FOR PERCOLATION TESTING AND SITE EVALUATION

RE: PERCOLATION TEST RESULTS-522062
Tax Map 29, Parcel 5
Sindler Property

RE: **Variance Request**
4671 Manor Lane

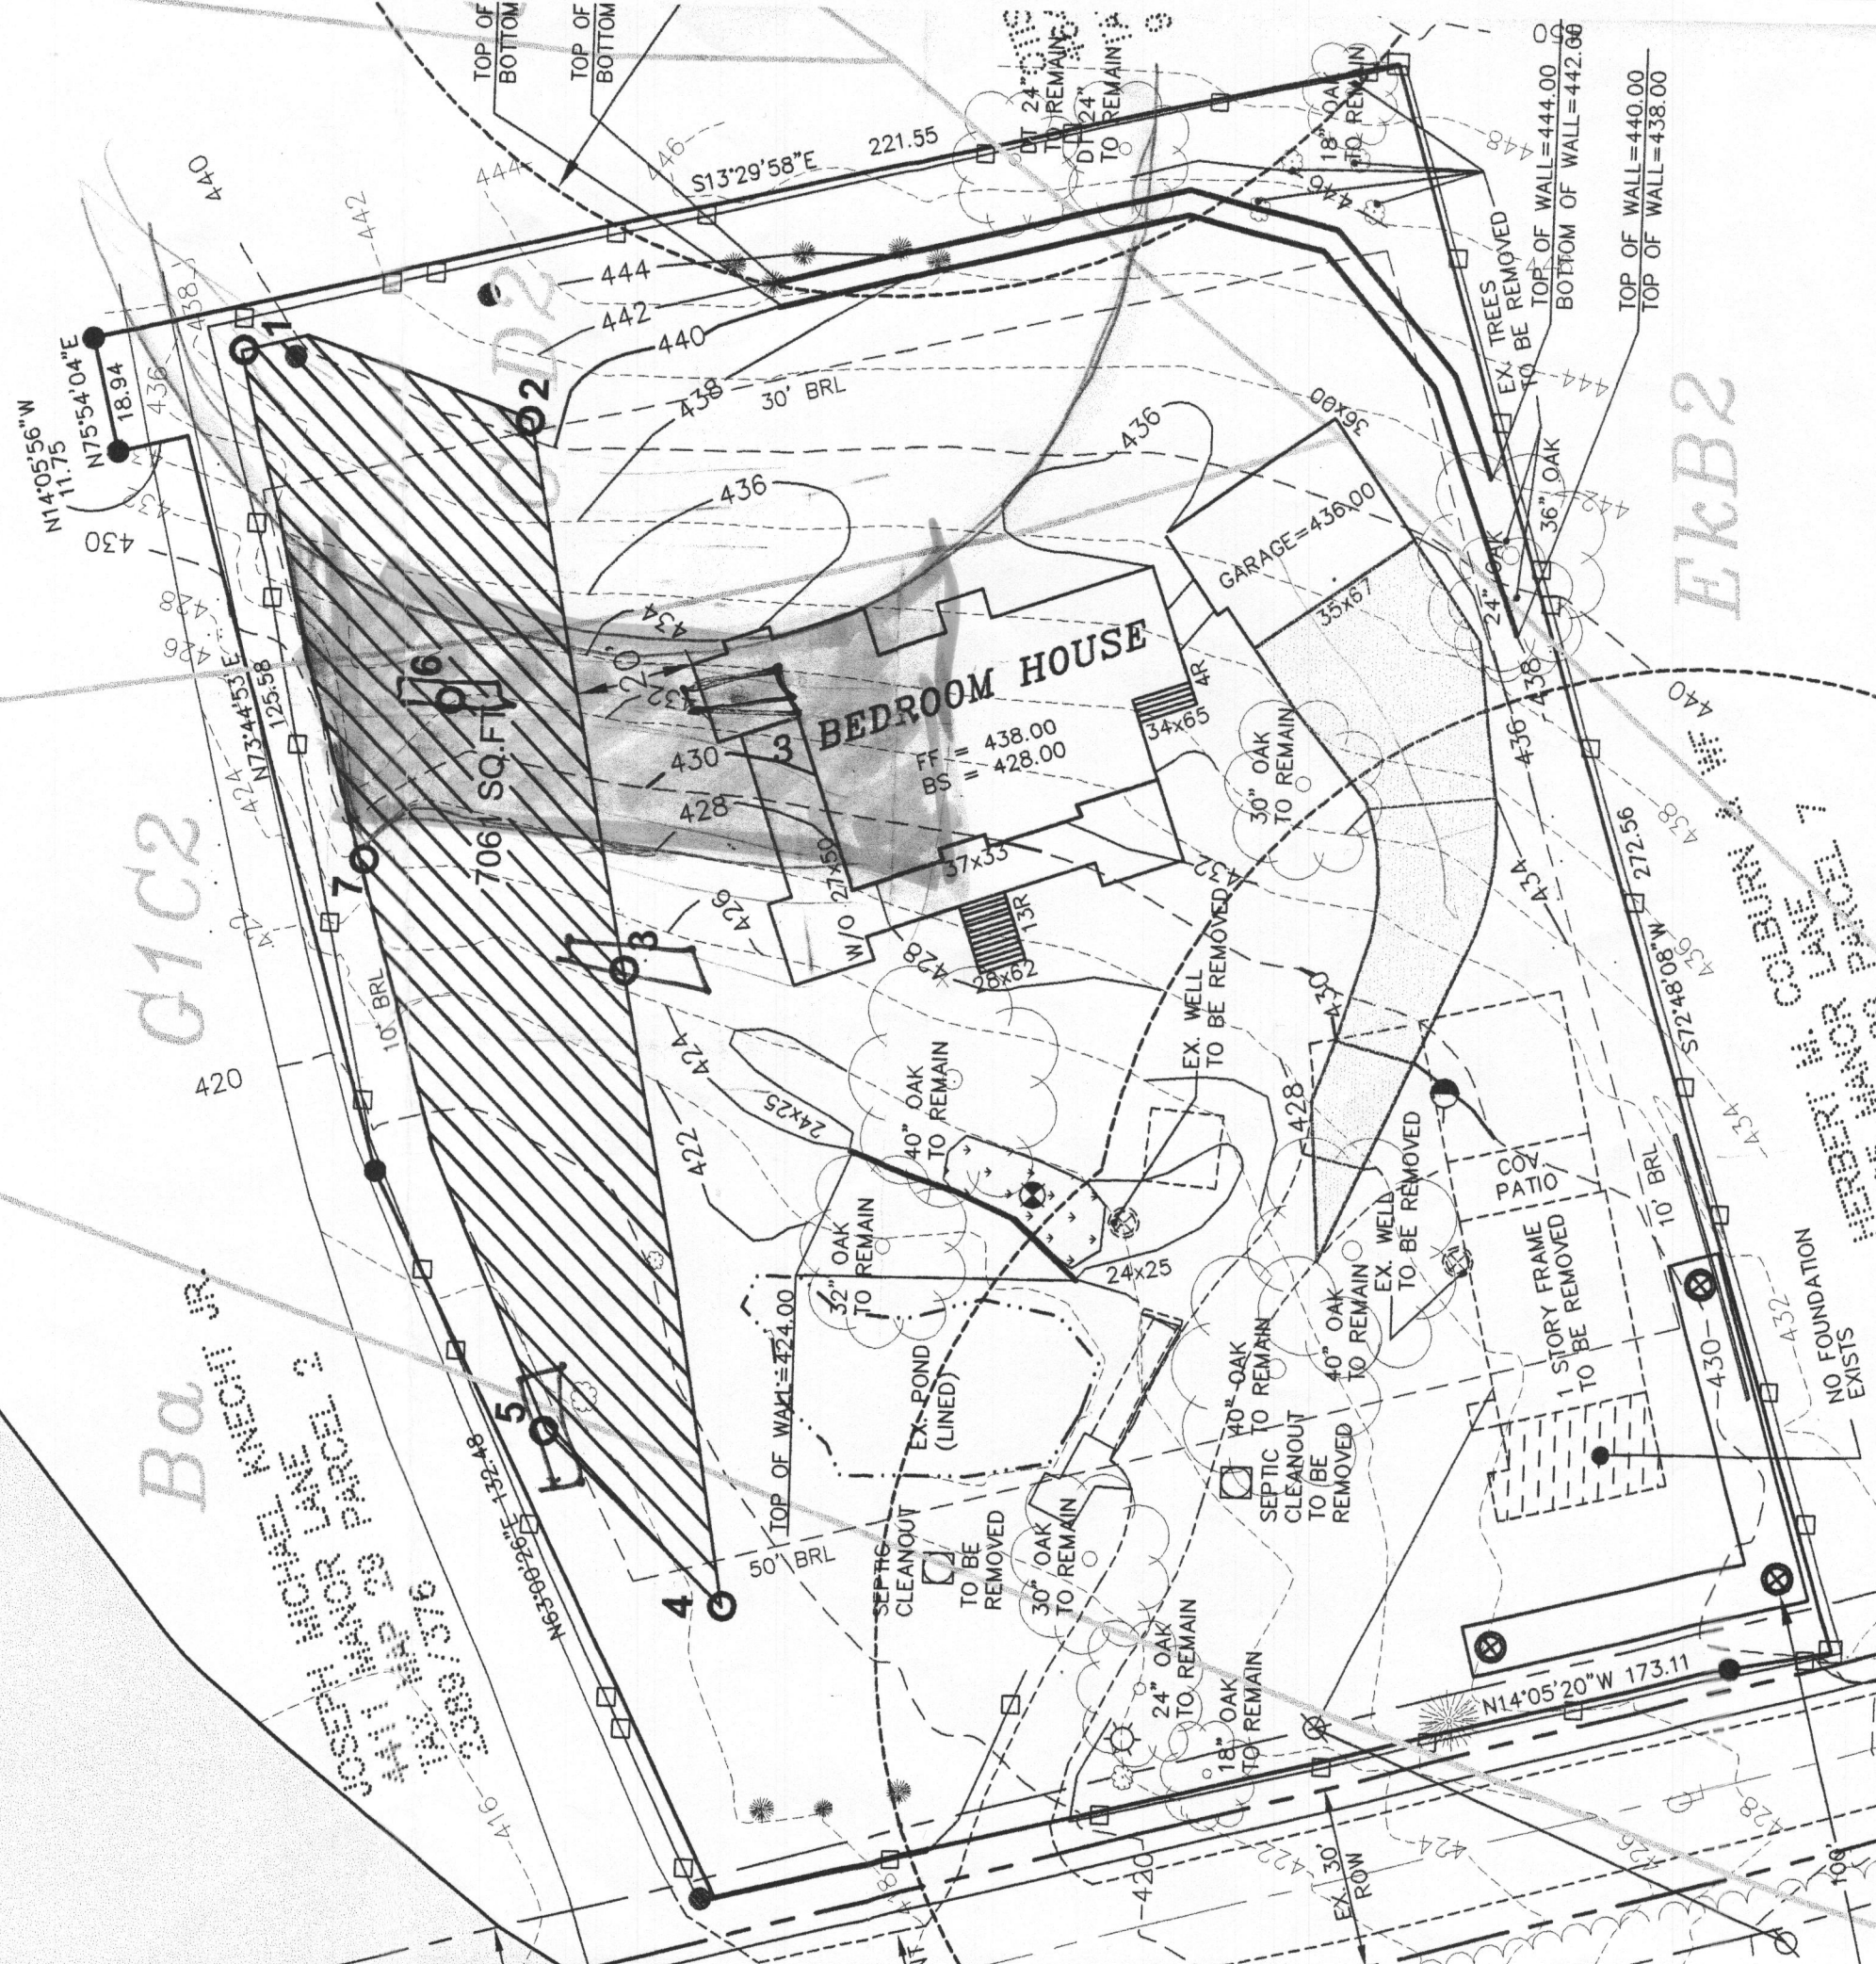
Per my correspondence with Mr. Peter Yencsik, I was informed that we would only be allowed to build a 3 bedroom house as opposed to 4 bedrooms as originally intended. Mr. Yencsik suggested that I request a variance from the 20' setback between the proposed house location and the septic area. In order for 4 bedrooms to be acceptable, the portion of the house that would encroach the 20' setback would not have a basement in that location.

Therefore, I am requesting a variance to the 20' septic easement to house setback. The house will have a 10' setback from the easement at the portion of the house, but the basement will maintain the 20' setback from the septic easement. By reducing the setback to 10', the septic area will increase from 4,378 sq.ft. to 4,944 sq.ft. The overall intent of this variance request is to increase the size of the septic area in order to be given permission to build a 4 bedroom house on this property. I have included a copy of the Percolation Certification Plan for your review and signature approval.
